Freescale Semiconductor, Inc.

ADDENDUM TO MC68341 Integrated Pro

April 19, 1995

Figure 3-12. M68300

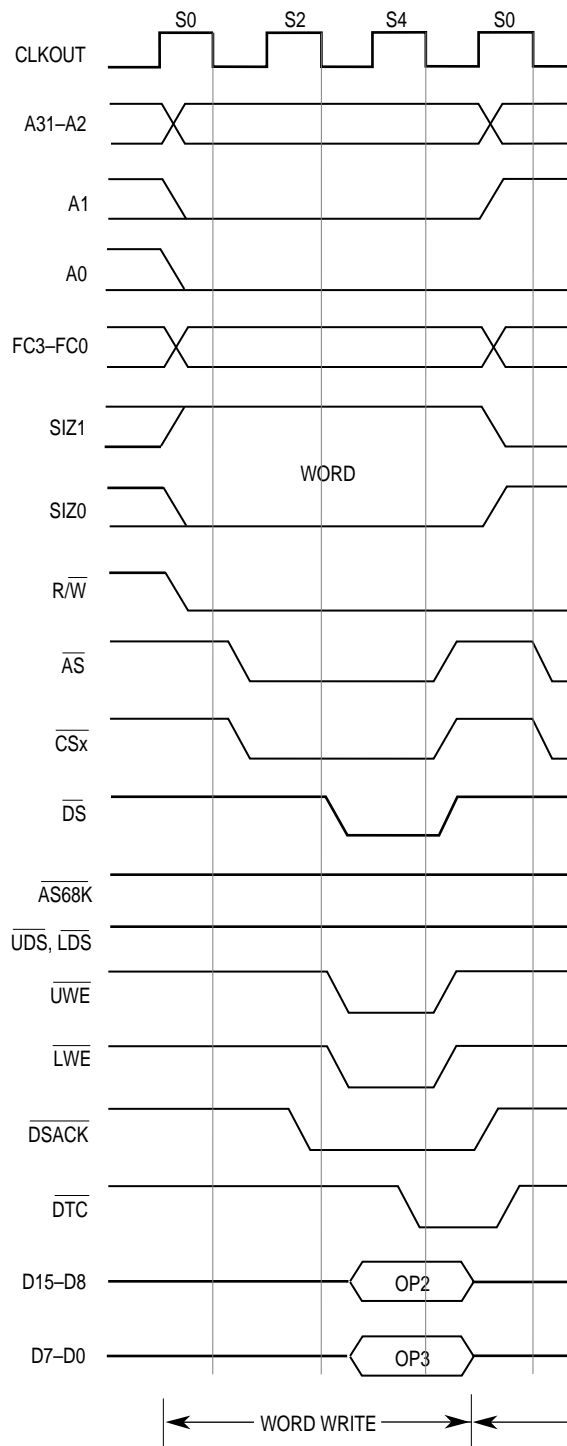
4. Write Cycle Timing Waveforms

On page 3-25, the M68300 write cycle timing diagram LWE. On page 3-28, the M68000 write cycle timing diagram CSx, UDS/LDS, and UWE/LWE. Replace these figures

Figure 11-14. Circuit For Interfacing the MC68341 to a Device in Single-Address Mode

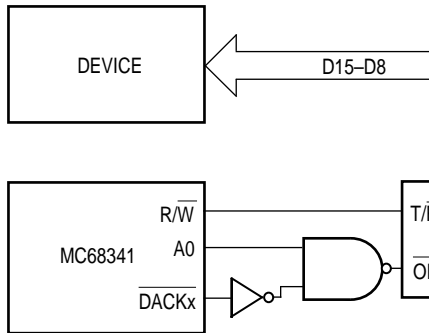
65. Corrections to 8/16-Bit DMA Cont

On page 11-10, the logic driving \overline{OE} on the 74F245 in Figure 11-14 is shown. Although not detailed, the byte enables for the memory block are shown. Attention between the upper and lower bytes of the data bus.
